UNITED STATES PATENT AND TRADEMARK OFFICE

APPLICATION NO.	FILING DATE	FIRST NAMED INVENTOR	ATTORNEY DOCKET NO.	CONFIRMATION NO.
15/332,415	10/24/2016	KEONWOO KIM	8021L-885 (DP-51609-US)	5295
22150	7590	09/26/2018		
F. CHAU & ASSOCIATES, LLC 130 WOODBURY ROAD WOODBURY, NY 11797			EXAMINER OJEH, NDUKA E	
			ART UNIT	PAPER NUMBER
			2892	
			NOTIFICATION DATE	DELIVERY MODE
			09/26/2018	ELECTRONIC

DETAILED ACTION

Examiner's Fig. 1

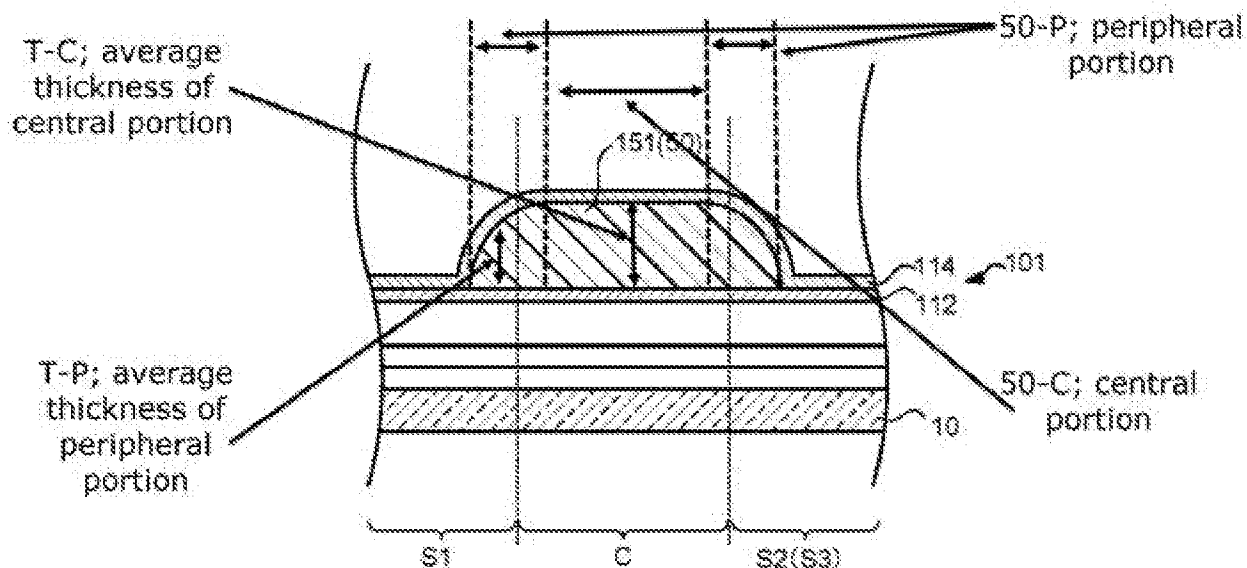
an organic material layer (50, fig. 5 and 13) [0053] arranged between the inorganic insulating layer (111) and the first conductive layer (114) (see fig. 13), contacting (indirect contact, fig. 13) the inorganic insulating layer (111), and comprising a central portion (50-C; see examiner's fig. 1) and a peripheral portion (50-P; see examiner's fig. 1),

wherein the central portion (50-C) overlaps with the bending area (C),

the peripheral portion (50-P) extends from the central portion (50-C), and

an average thickness of the central portion (50-C) is greater than (see examiner's fig. 1) an average thickness of the peripheral portion (50-P) (Fujiyoshi et al., fig. 15 and 13).

Fig. 13 is the embodiment chosen for the rejection and the portion of fig. 13 is substituted for the middle portion/middle pair of squiggly lines of fig. 5.

In order to overcome the current grounds of rejection, the claim must recite that the organic material layer is in direct contact with the inorganic insulating layer because using the broadest reasonable interpretation, "contact" can include intervening layers while "direct contact" cannot include intervening layers.

Regarding claim 3, Fujiyoshi teaches the display apparatus of claim 1, wherein the central portion (50-C) has a substantially uniform thickness (see examiner's fig. 1)

Regarding claim 5, Fujiyoshi teaches the display apparatus of claim 1, wherein a thickness of the peripheral portion (50-P) gradually decreases in a direction away from the central portion (50-C) (see examiner's fig. 1) (Fujiyoshi et al., fig. 13).

Examiner's fig. 2

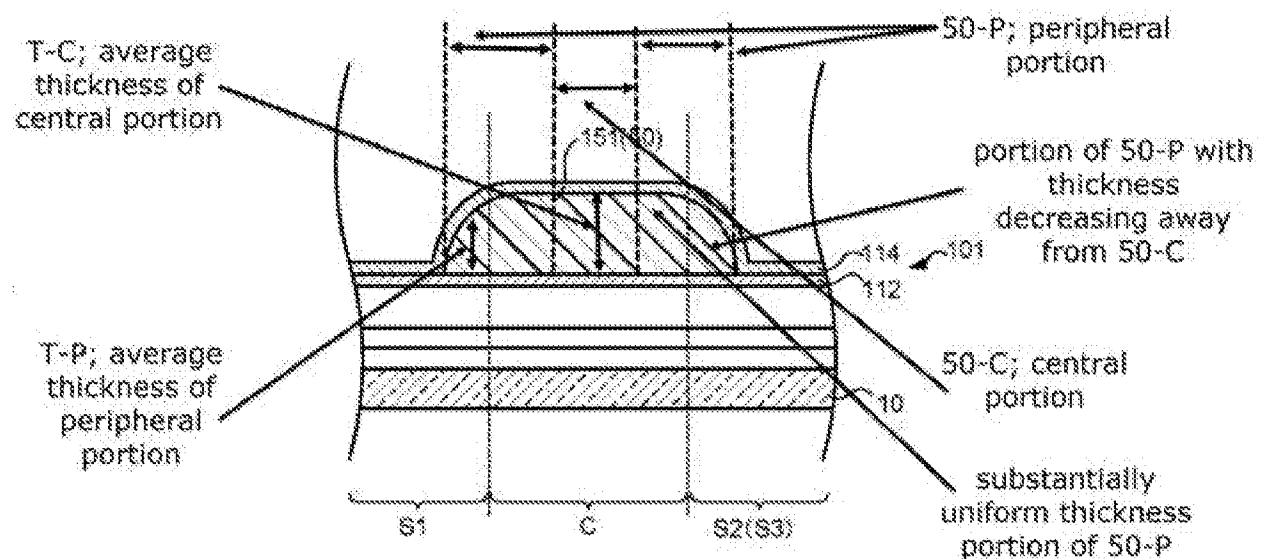
an organic material layer (50, fig. 5 and 13) [0053] arranged between the inorganic insulating layer (111) and the first conductive layer (114) (see fig. 13), contacting (indirect contact, fig, 13) the inorganic insulating layer (111), and comprising a central portion (50-C; see examiner's fig. 2) and a peripheral portion (50-P; see examiner's fig. 2),

wherein the central portion (50-C) overlaps with the bending area (C),
the peripheral portion (50-P) extends from the central portion (50-C), and
an average thickness of the central portion (50-C) is greater than (see

examiner's fig. 2) an average thickness of the peripheral portion (50-P) (Fujiyoshi et al., fig. 15 and 13).

Fig. 13 is the embodiment chosen for the rejection and the portion of fig. 13 is substituted for the middle portion/middle pair of squiggly lines of fig. 5.

Regarding claim 4, Fujiyoshi teaches the display apparatus of claim 1, wherein the peripheral portion (50-P) comprises an area having a substantially uniform thickness (see examiner's fig. 2), and a thickness of the peripheral portion (see examiner's fig. 2) decreases in a direction away from the central portion (see examiner's fig. 2) (Fujiyoshi et al., fig. 13).

Examiner's Fig. 3

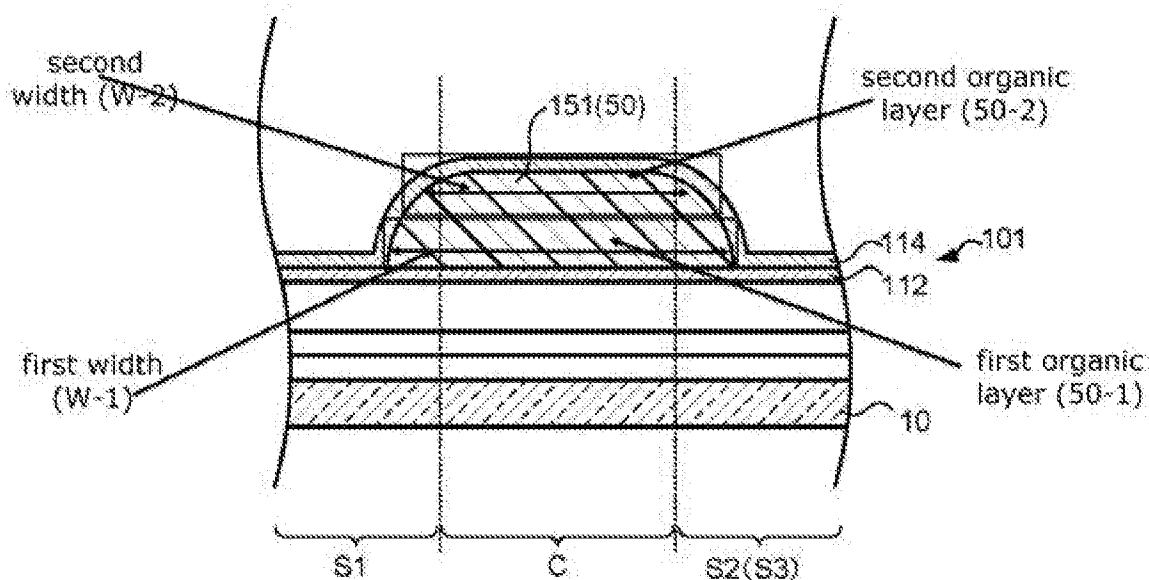
wherein the organic material (50) layer comprises: a first organic material layer (bottom half portion of 50; hereinafter 50-1, see examiner's fig. 3); and a second organic material layer (top half portion of 50; hereinafter 50-2, see examiner's fig. 3) arranged on the first organic material layer (50-1), wherein the first organic material layer (50-1) has a first width (hereinafter W-1, see examiner's fig. 3), the second organic material layer (50-2) has a second width (hereinafter W-2, see examiner's fig. 3) smaller than the first width (W-1), the second width (W-2) is greater than a width of the bending area (C) (examiner's fig. 3) (Fujiyoshi et al., fig. 13).

Examiner's fig. 4

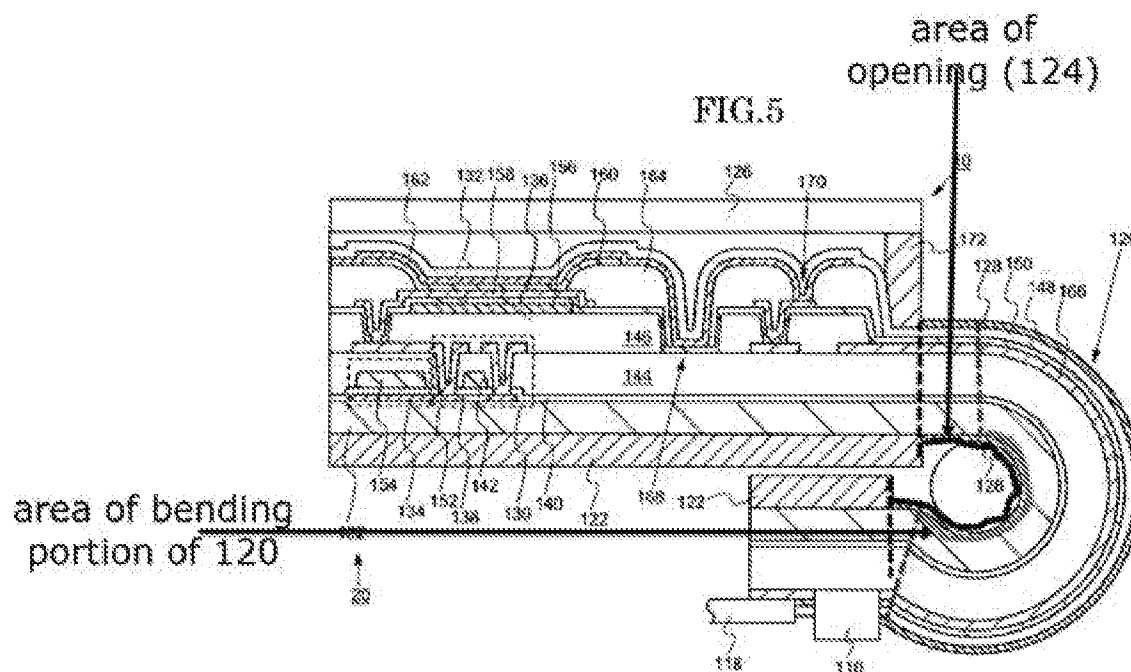
Regarding claim 21, Fujiyoshi in view of Cheng teaches the display apparatus of claim 20, wherein an area (see examiner's fig. 4) of the opening (124) is larger than an area (see examiner's fig. 4) of the bending area (bent portion of 120) (Cheng, fig. 5).
